Work Order ID 75790

Item Name: Crosstube Aft

DESIGN	Q	DART AEROSPACE LTD	
DRAWN	RF	HAWKESBURY, ONTARIO, CANADA	
CHECKED	Q	DRAWING NO.	REV. C
MFG. APPR.	Q	D206-667-243	SHEET 2 OF 4
APPROVED	RF	TITLE	SCALE
DE APPR.	RF	CROSSTUBE ASSY (206L HIGH AFT)	NTS
DATE	08.11.06	COPYRIGHT © 2000 BY DART AEROSPACE LTD	
THIS DOCUMENT IS PRIVATE AND CONFIDENTIAL AND IS SUPPLIED ON THE EXPRESS CONDITION THAT IT IS NOT TO BE USED FOR ANY PURPOSES OR COPIED OR COMMUNICATED TO ANY OTHER PERSON WITHOUT WRITTEN PERMISSION FROM DART AEROSPACE LTD.

DRAWING NO. D206-667-243	TITLE CROSSTUBE ASS'Y (206L HIGH AFT)	REV. C	DART AEROSPACE LTD ENGINEERING ORDER		D.E.O. NO. D206-667-243-C-1	SHEET NO. SHEET 1 OF 1	SCALE NTS
DRAWN <i>qp</i>	CHECKED <i>ADD</i>	MFG. APPR. <i>RB</i>	APPROVED <i>MD</i>	DE APPR. <i>#</i>			
DATE 11.07.15	DATE 11.07.20	DATE 11.07.21	DATE 11/07/21	DATE 11.07.21

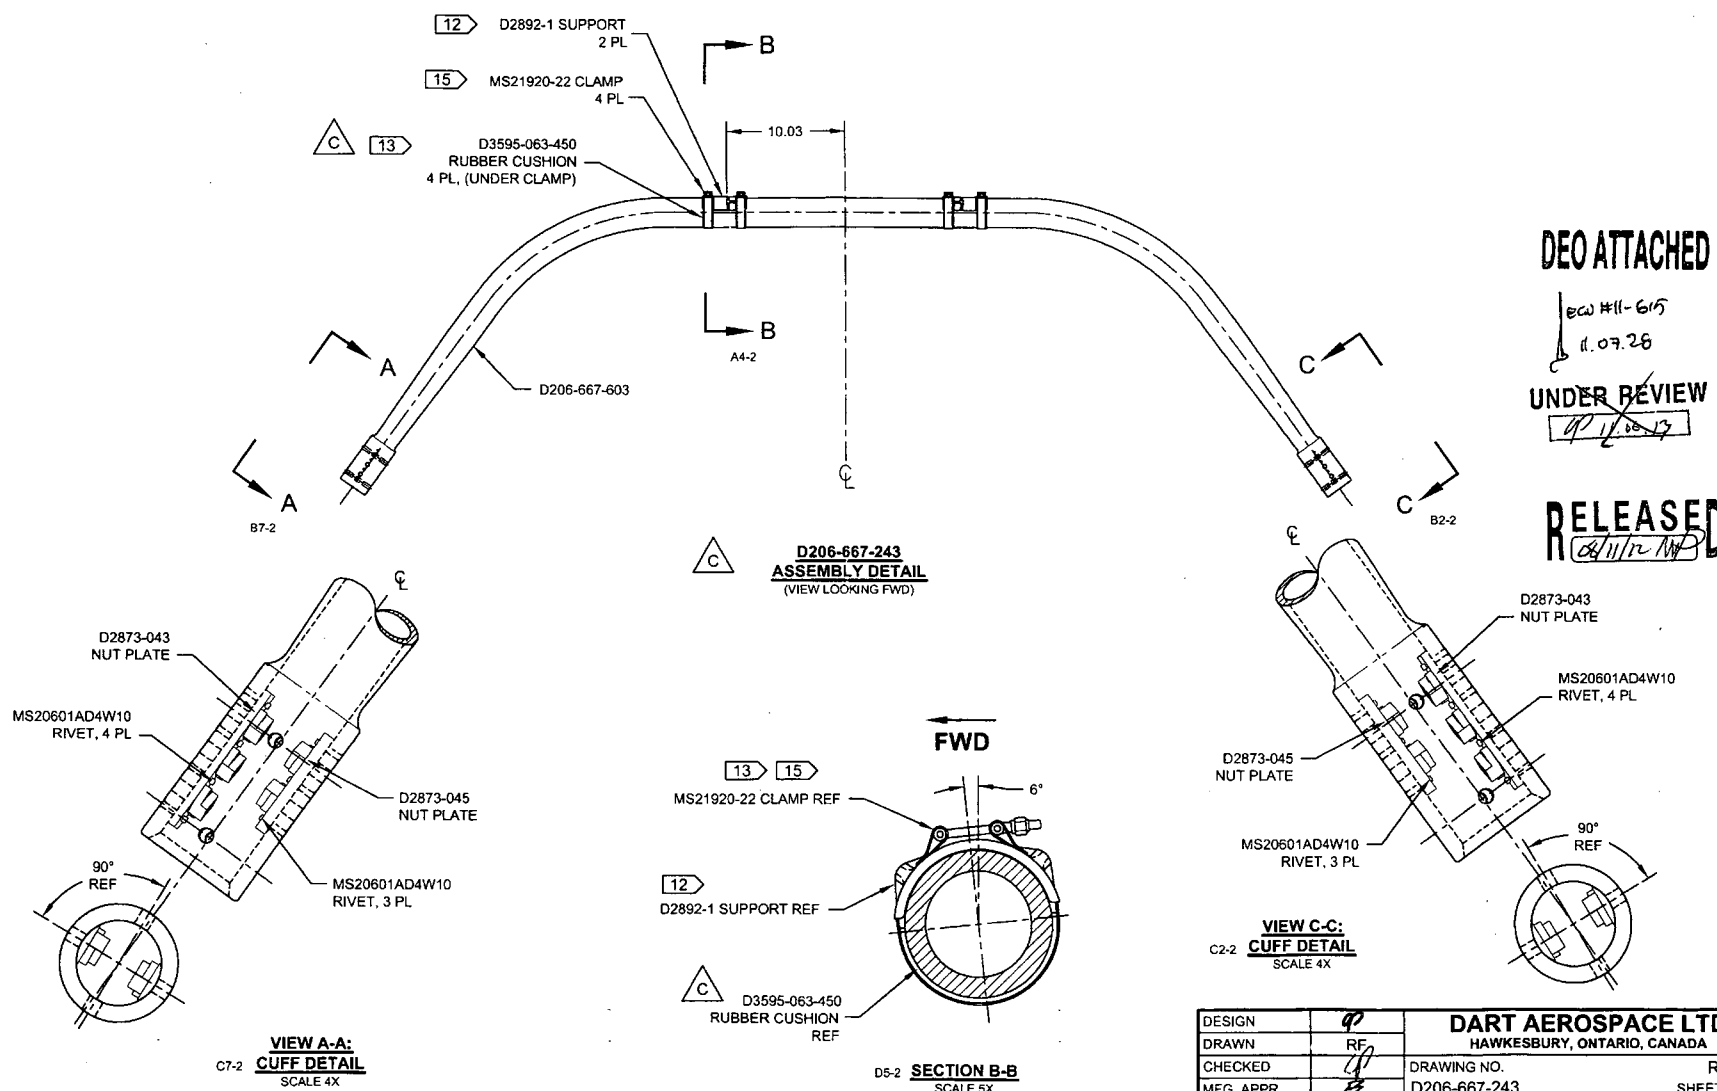
DEO ATTACHED
ECW #11-615
11.07.26
UNDER REVIEW
07/11/08
RELEASED
08/11/08

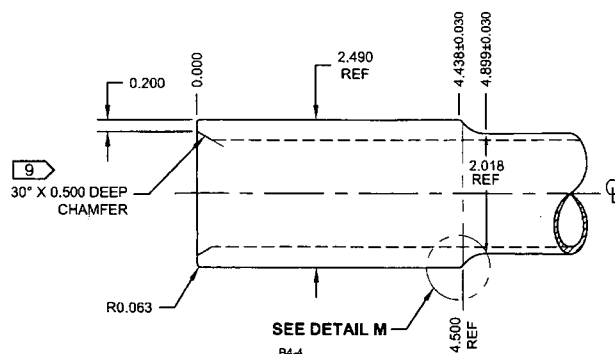
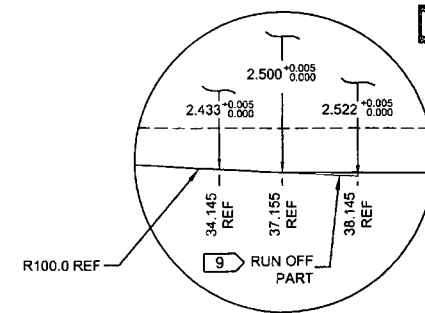
ECN #11-615
11.07.28

DEO ATTACHED
